INVITATION TO TENDER "ITT" PS20201112
CONTRACTOR FOR ANDERSON STREET UTILITY UPGRADE

ADDENDUM NO. 6

RE: REPLACE DRAWINGS

PROJECT
CITY OF VANCOUVER
ANDERSON STREET UTILITY UPGRADES

PROJECT CITY OF VANCOUVER ANDERSON STREET UTILITY UPGRADES			
TITLE KEY PLAN AND SURVEY CONTROL			
CLIENT PROJECT No.	WSE PROJECT No.	DRAWING No.	REV.
-	234	G-003	1

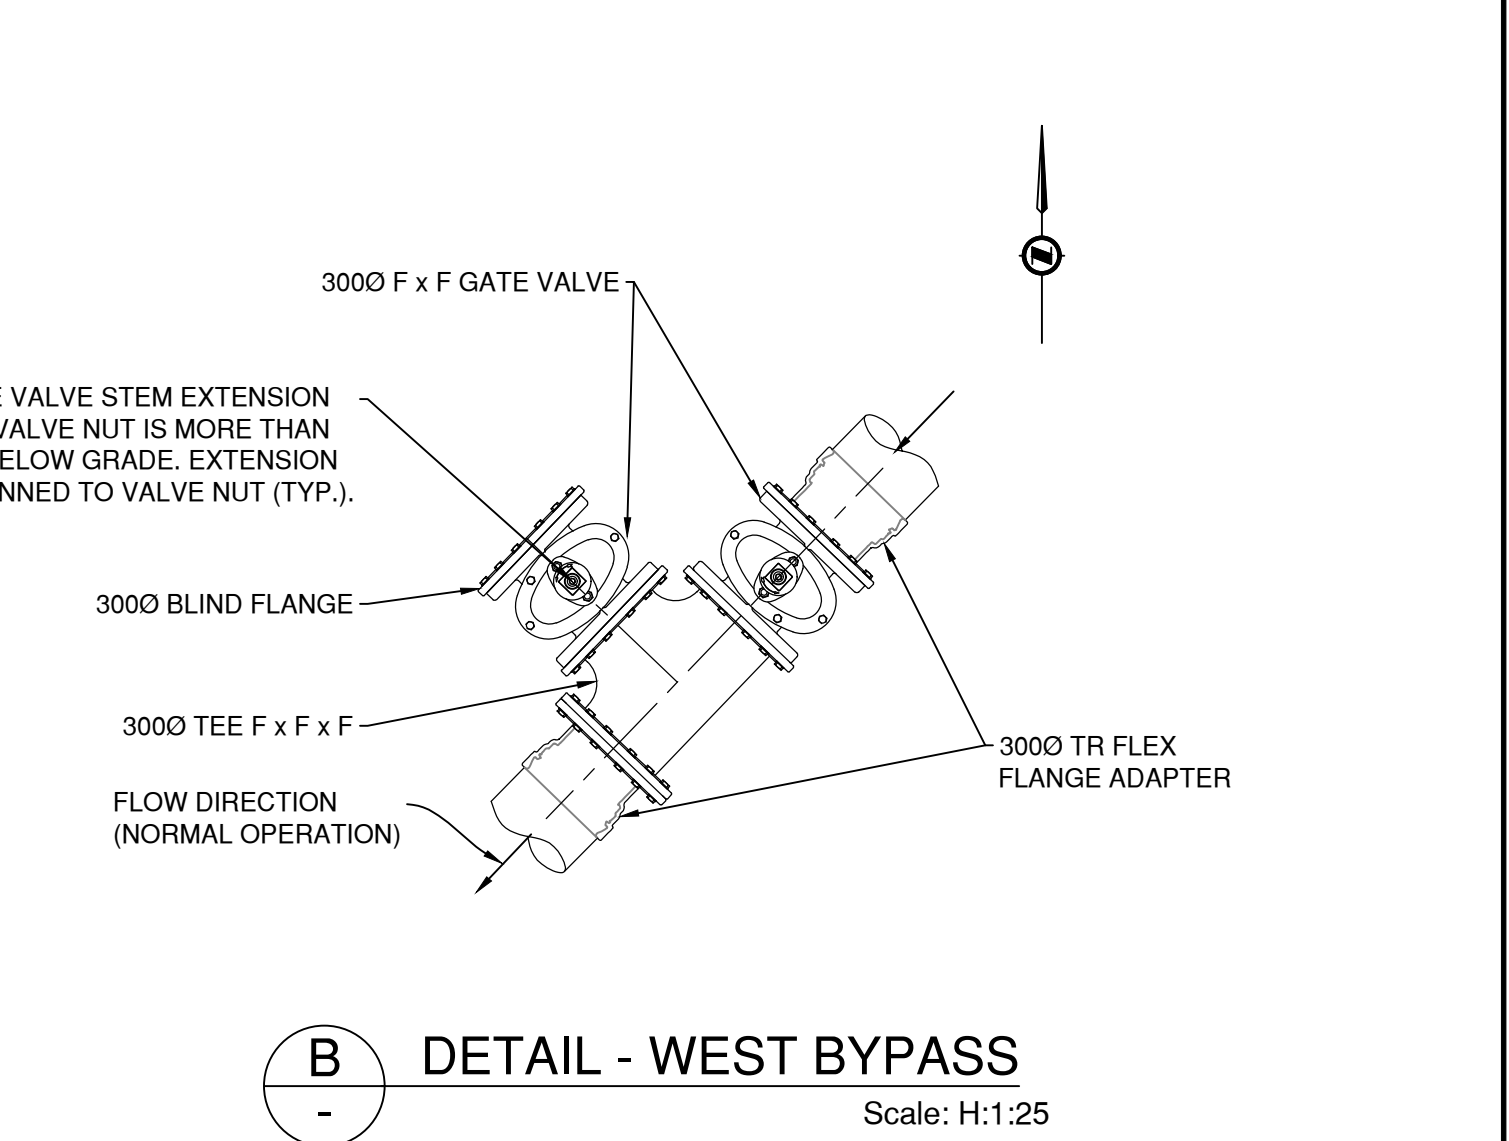
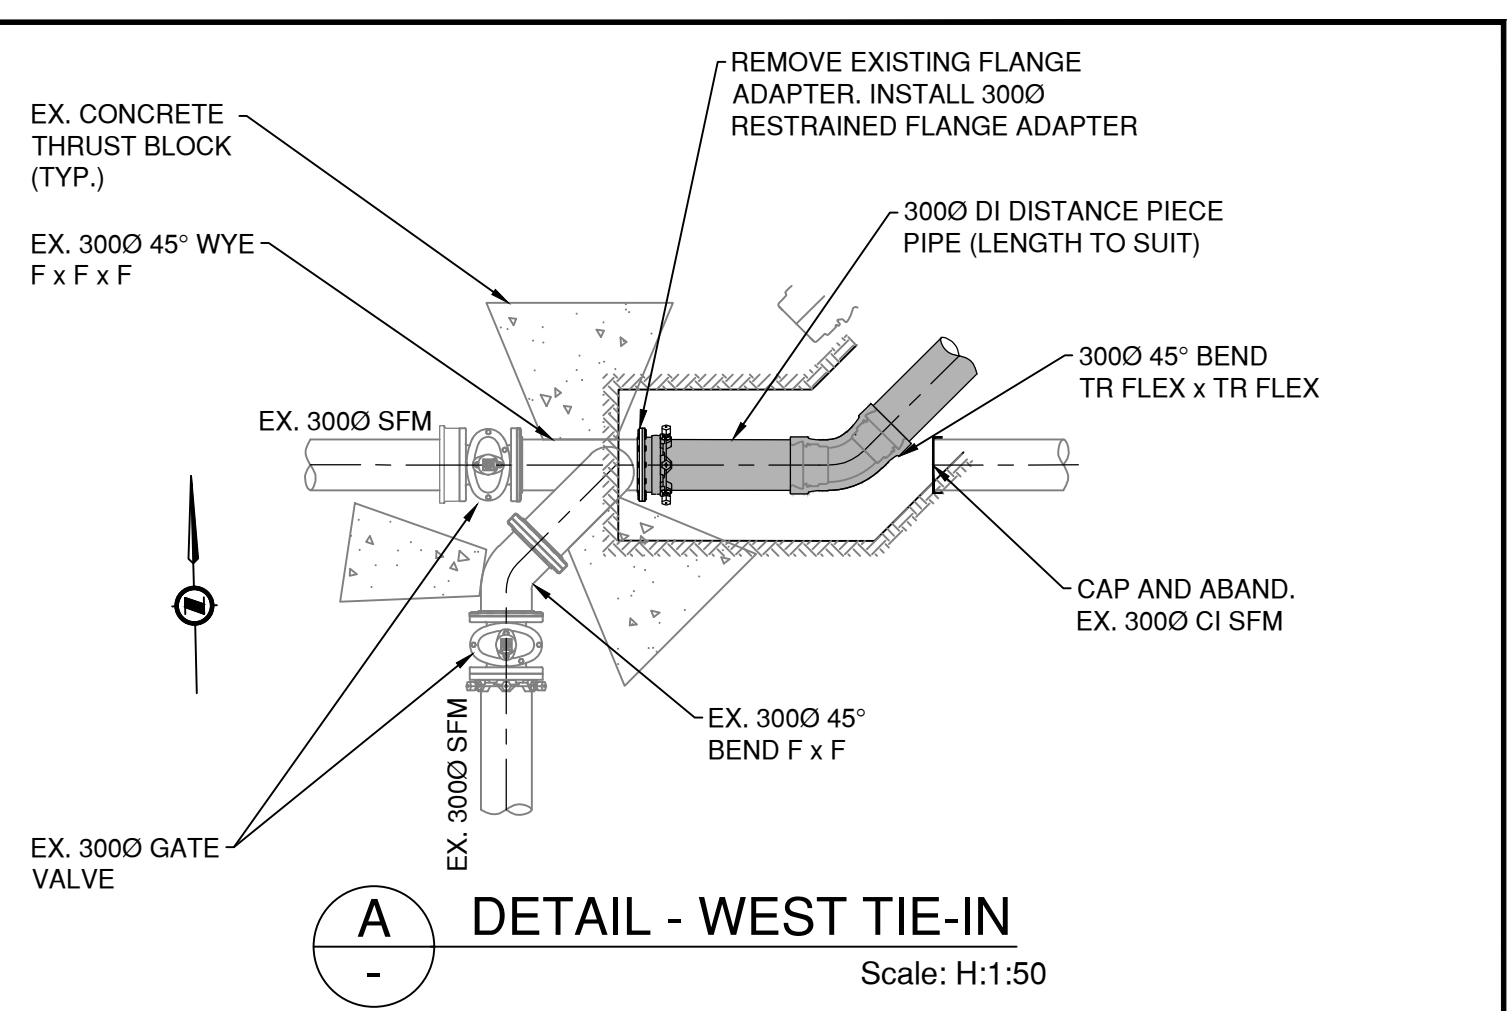
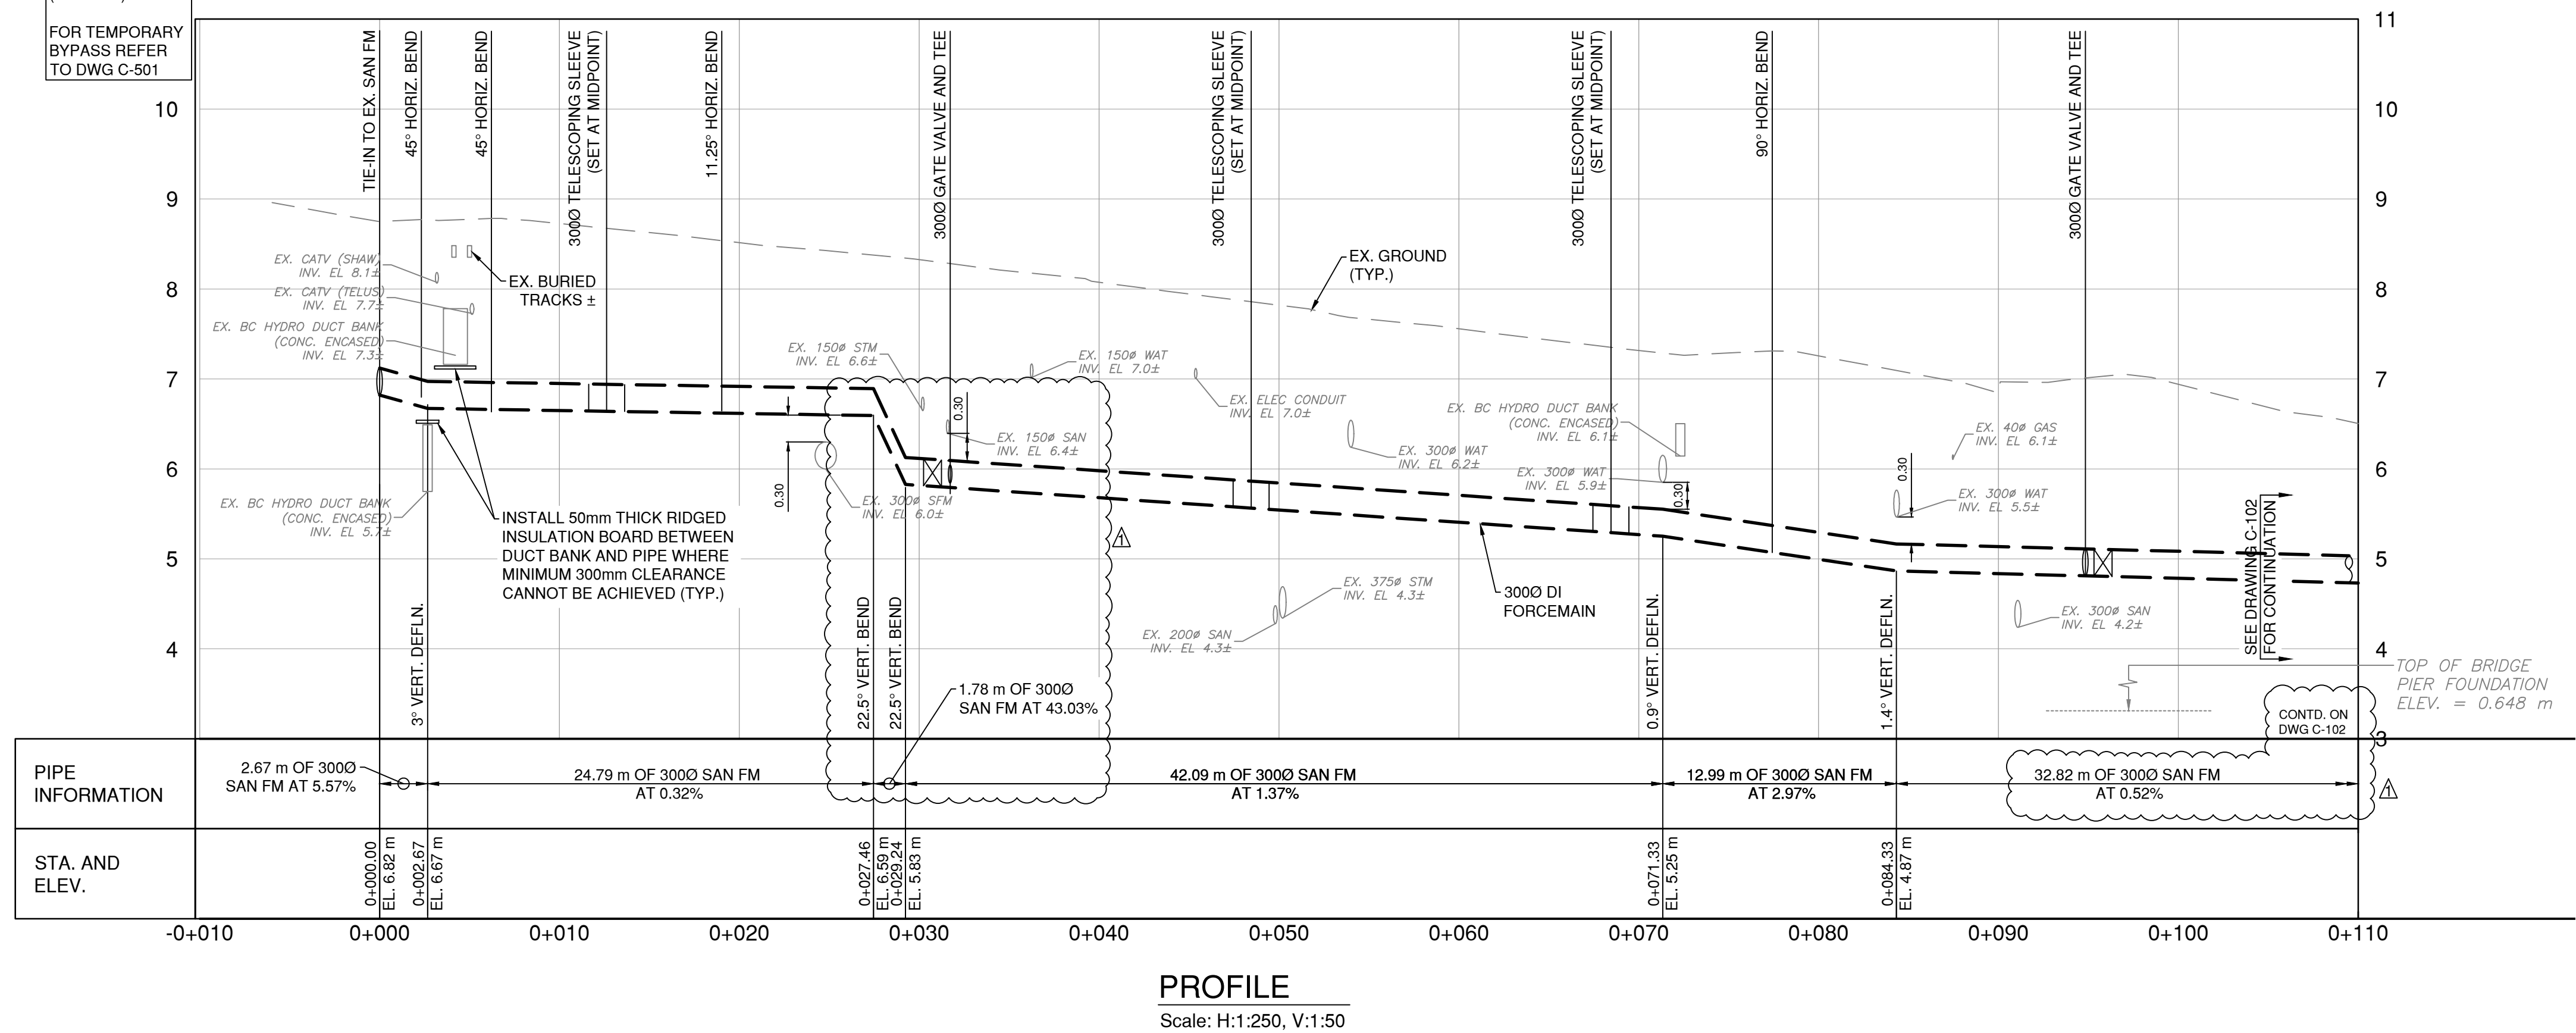
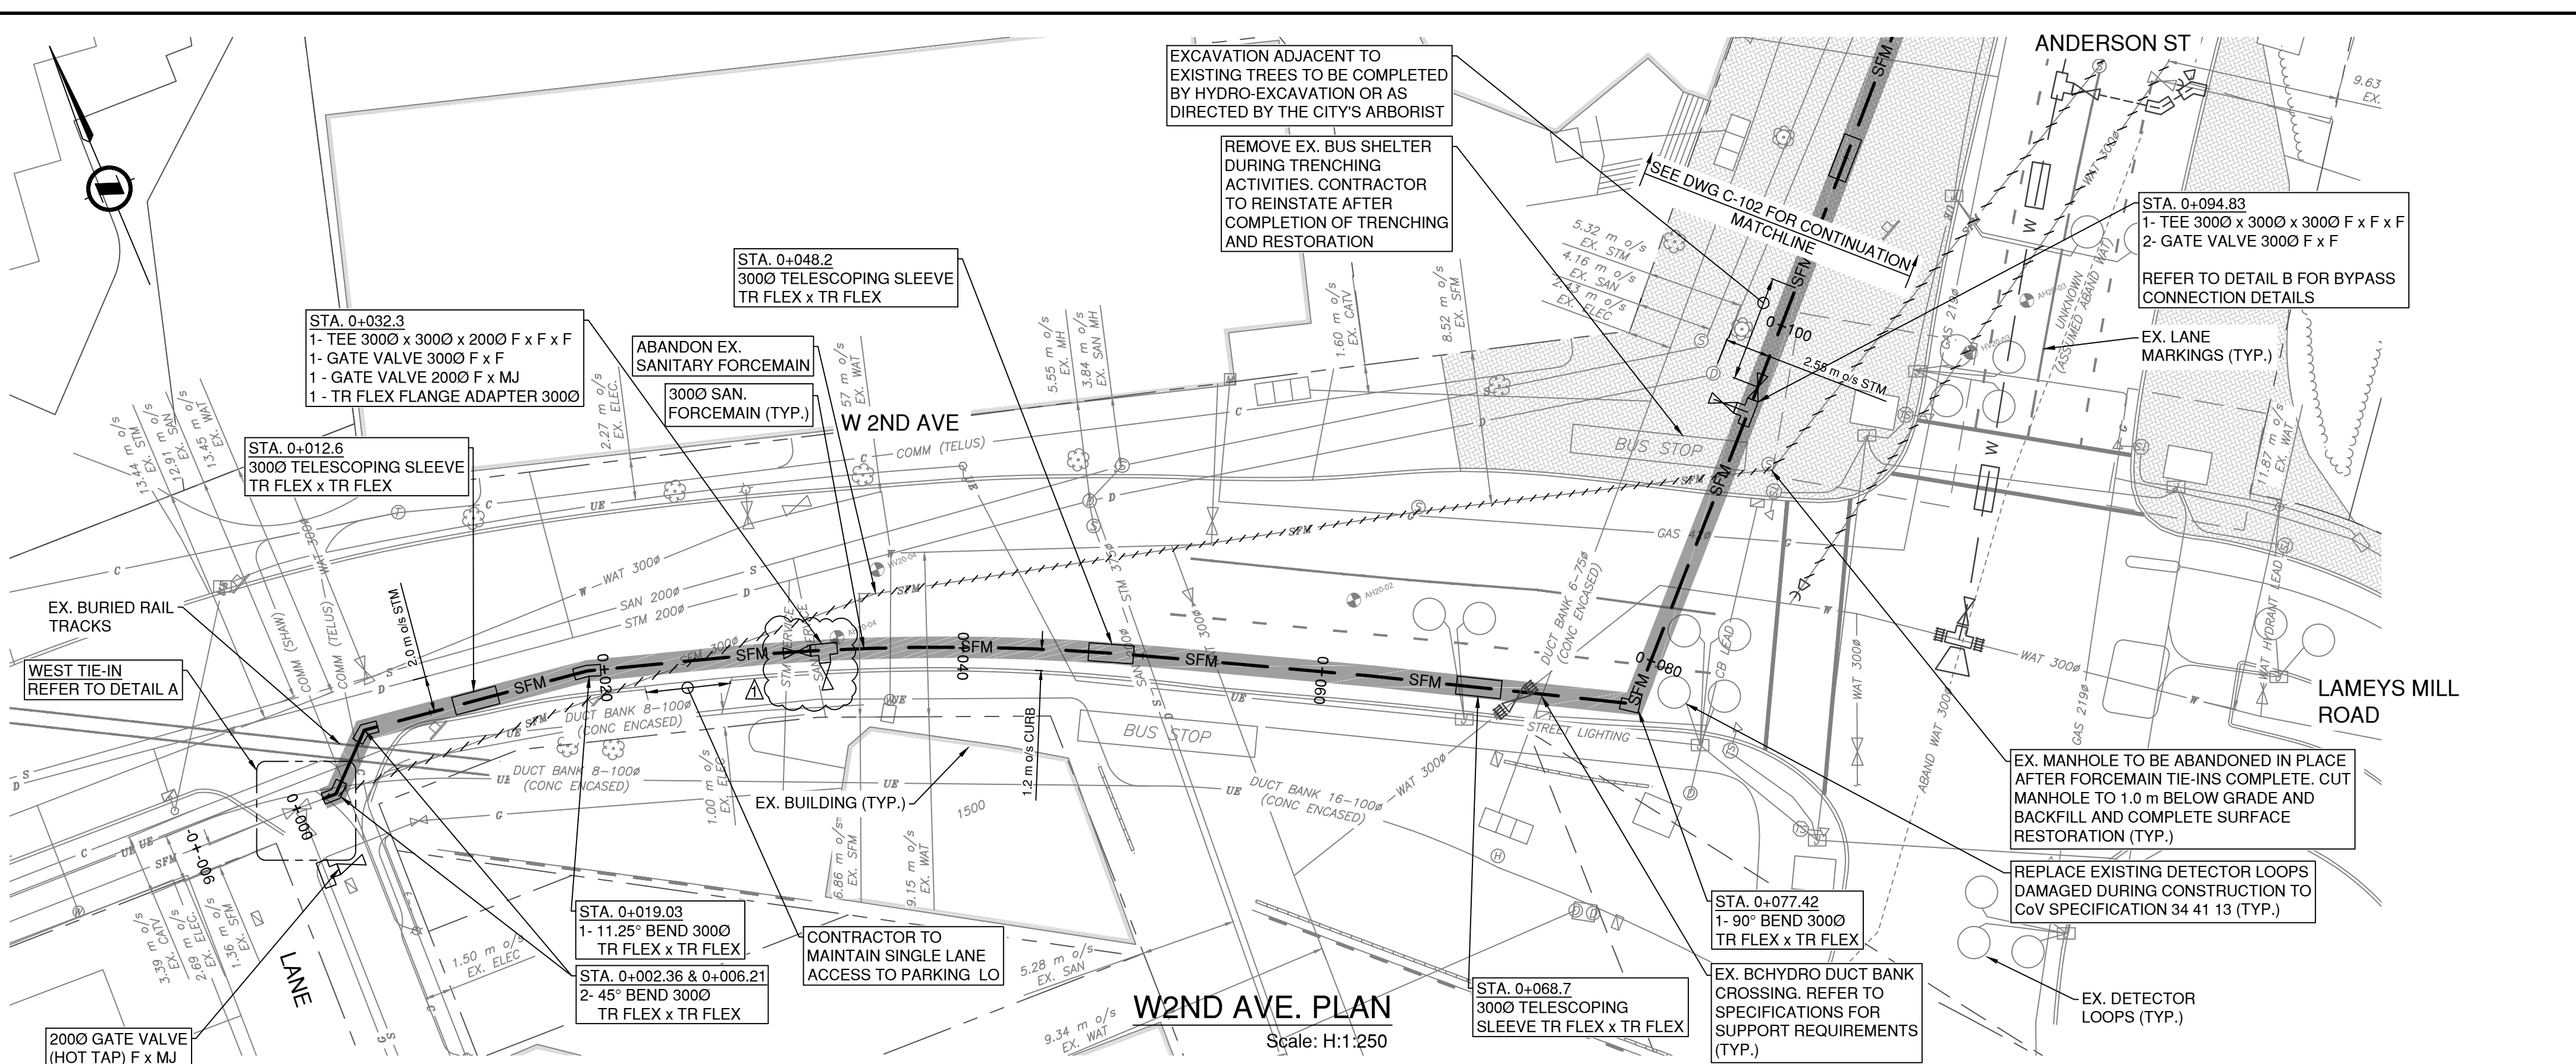
REV	BY	DATE	DESCRIPTION	DES	CHK
0	SP	14-OCT-2020	ISSUED FOR TENDER	SF	AB
1	SF	06-NOV-2020	LAYDOWN AREA BOUNDARIES ADDED	SF	AB
